Re: Petition No. 1120 – The United Illuminating Company Petition for a Declaratory Ruling that no Certificate of Environmental Compatibility and Public Need is Required for the Proposed Modifications to the Hawthorne Substation at 180 Hawthorne Drive, Fairfield, Connecticut

Pursuant to Section 16-50j-62(a)(1) of the Regulations of Connecticut State Agencies, The United Illuminating Company (“UI”) submits the following proposed Development and Management (“D&M”) Plan change request in the above referenced Petition.

figure 6
 UPDATED SITE PLAN
 STORMWATER POLLUTION CONTROL PLAN
 180 HAWTHORNE DRIVE
 Fairfield, Connecticut

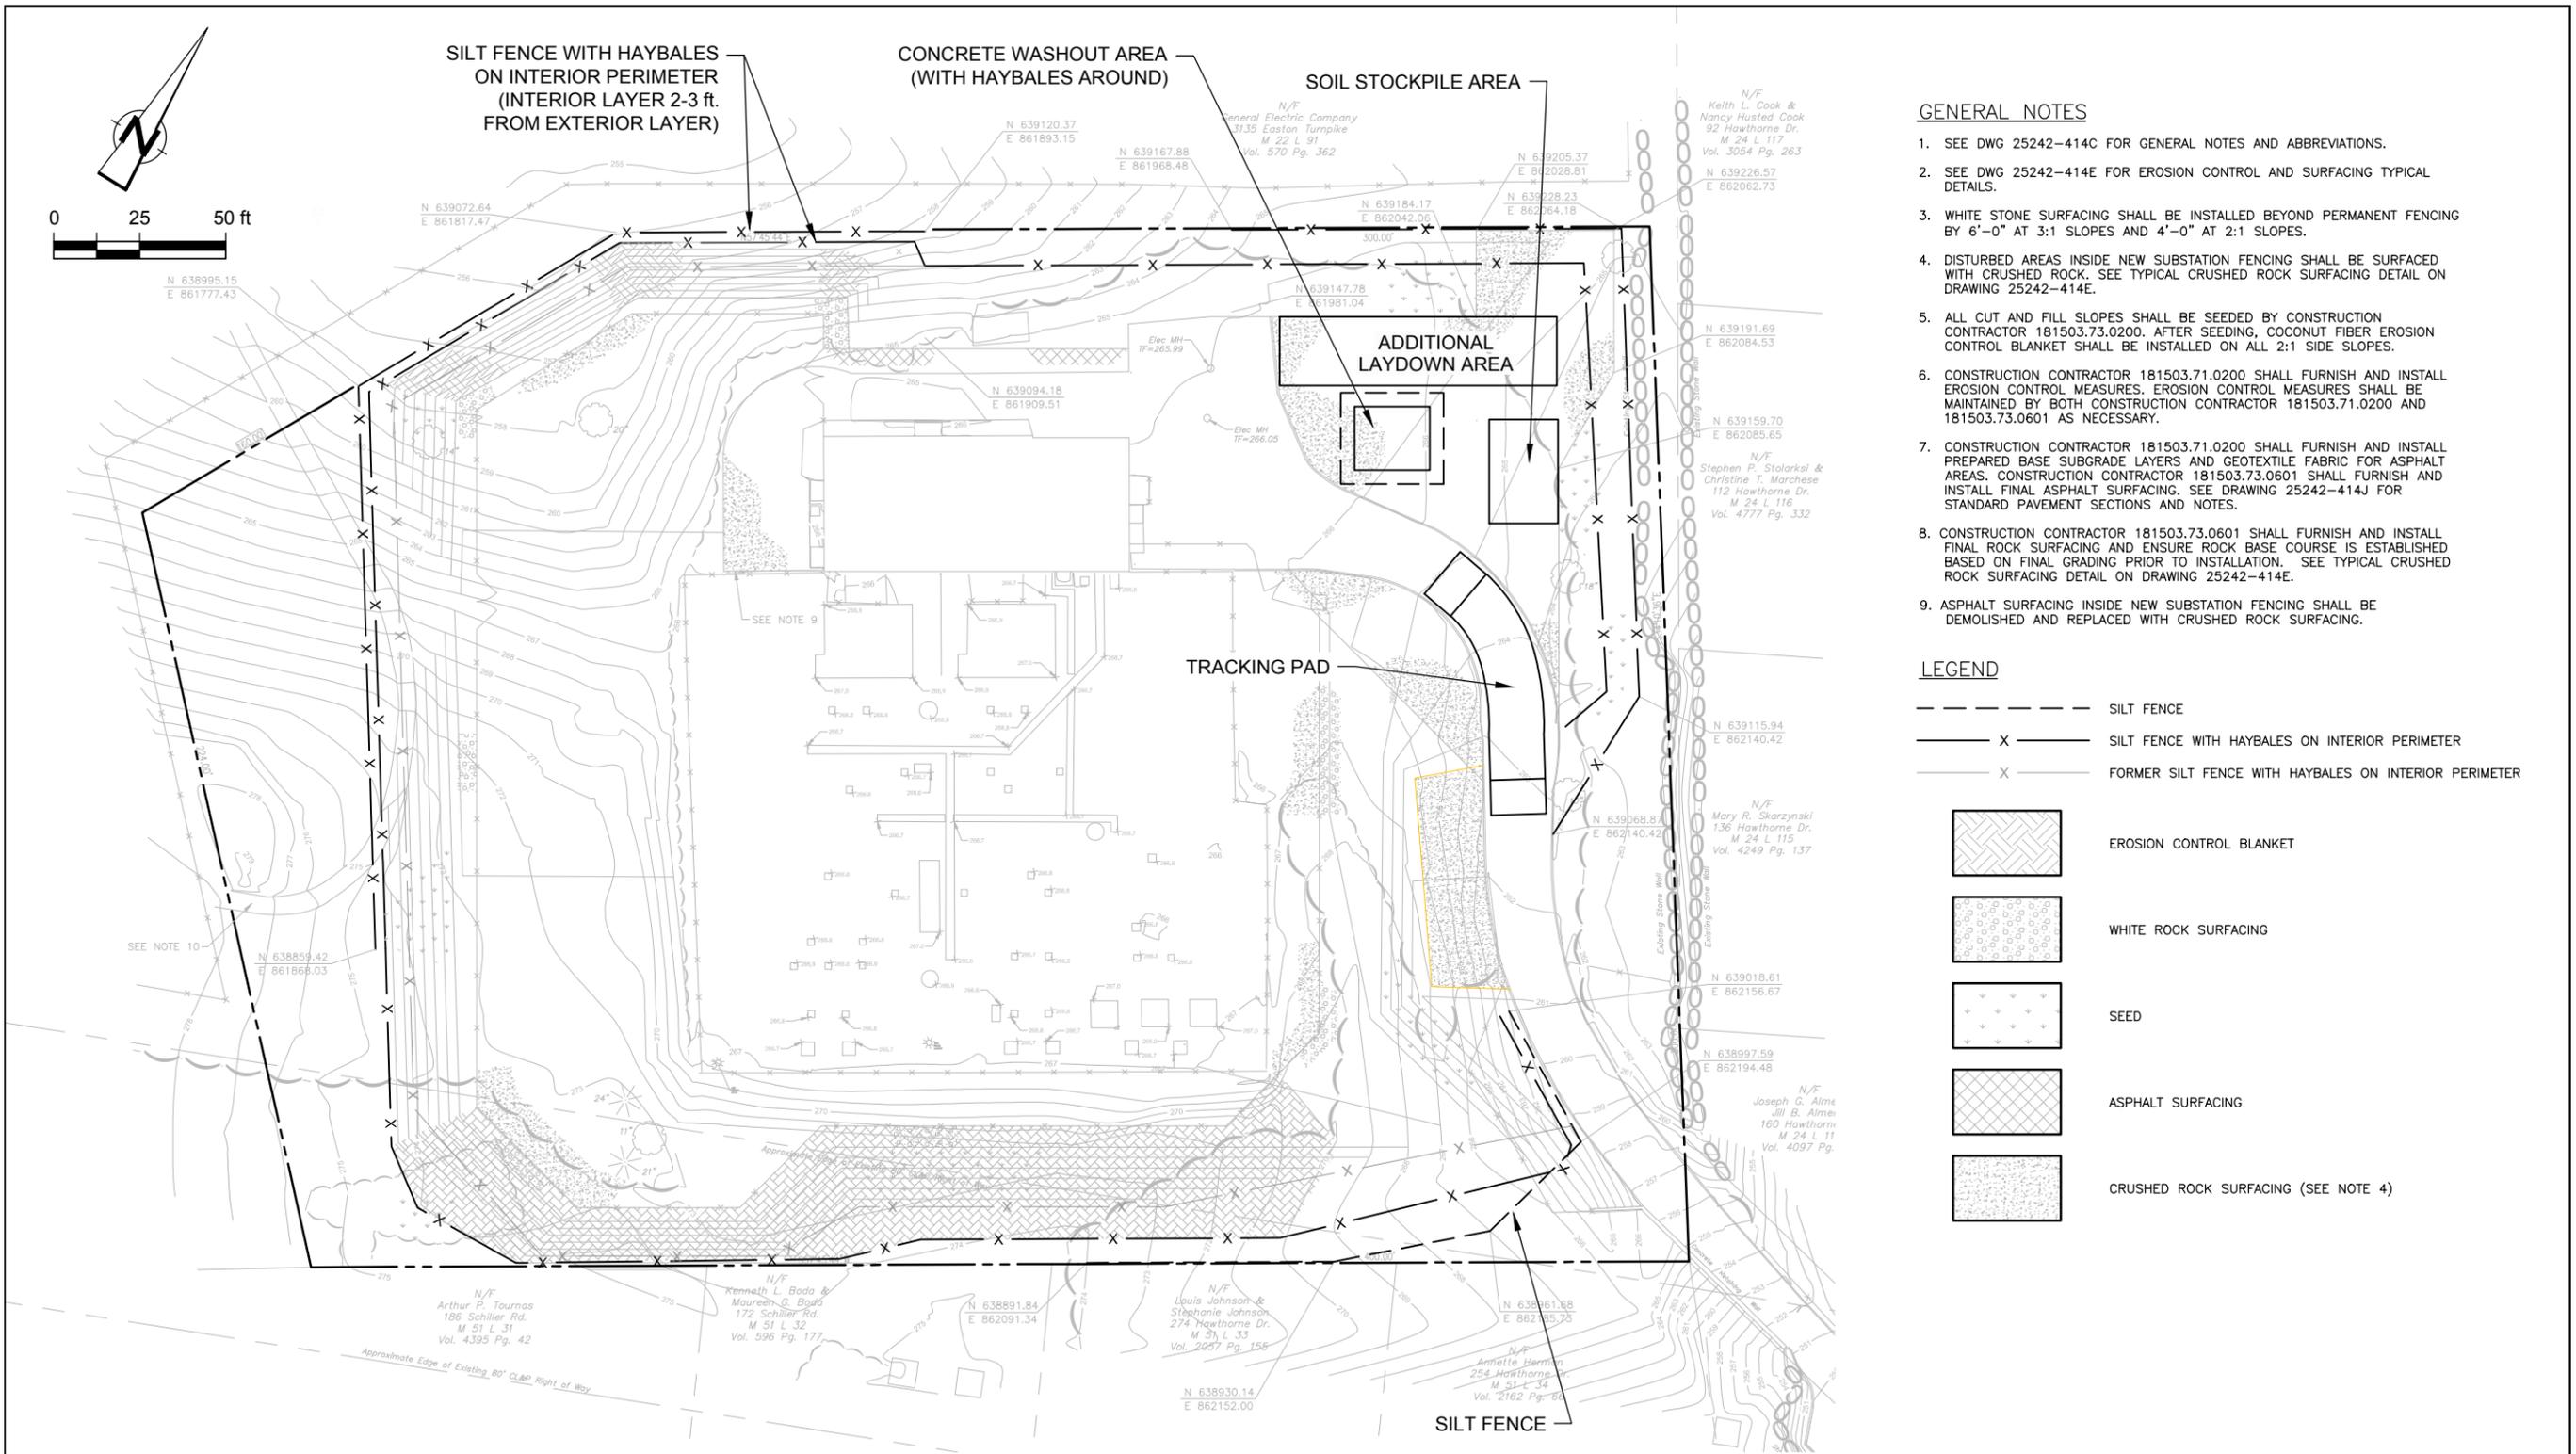
Specifically, in certain areas on the site, UI placed two rows of silt fencing as part of its stormwater pollution control and eastern box turtle management plans, as detailed in Appendix B, Figure 5 of the D&M Plan. UI proposes to reconfigure the distance between the two rows of silt fencing. UI constructed the silt fencing as contemplated and approved by the Connecticut Siting Council (“Council”) – maintaining ten feet of separation between the two rows. However, doing so impedes UI’s ability to construct proper slope ratios along the southern, western, and northwestern edges of the site. To facilitate the construction of proper slopes, UI must move one row of silt fencing closer to the other in the areas referenced above by a minimum of two feet and a maximum of eight feet, depending on the area. UI will maintain the outer layer of silt fencing while repositioning the inner layer at all times. I have enclosed a drawing depicting this proposed change for your review.
